Office Action Summary

10/611,978

Tianjie Chen

Final Rejection***Election/Restrictions***

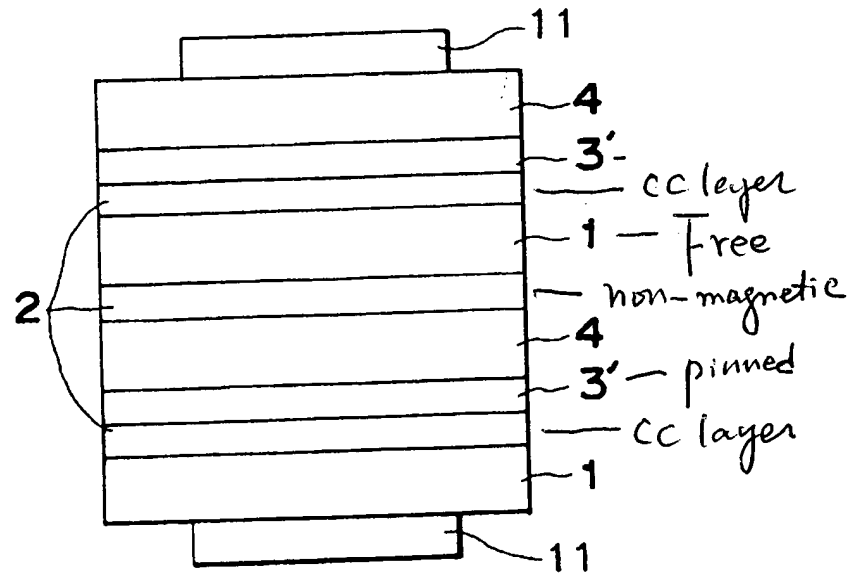
Claim 1, Sakakima et al shows a CPP spin-valve element with two electrodes 11 and 11 (Column 3, line 20) formed on an inherent substrate (See Fig. 5 attached above and column 5, lines 4 – 49) including: a free layer structure including at least one ferromagnetic layer; a pinned layer structure including at least one ferromagnetic layer, the free layer is magnetically softer than the pinned layer (column 4, lines 376-39); a thin non-magnetic spacer layer structure configured to separate the free layer and the pinned layer to prevent a magnetic coupling between the free and pinned layer structures, and to allow an electric current to go there through; and wherein at least two current-confining (CC) layer structures 2 including at least two parts 21 and 22 having significantly different current conductivities (Fig. 2A and 2B, column 3, lines

Claim 8, Sakakima et al further shows in Fig. 5 attached above that one of the CC-layer structures is located in the vicinity of the free layer structure, and another of the CC-layer structures is located in the vicinity of the pinned layer structure.
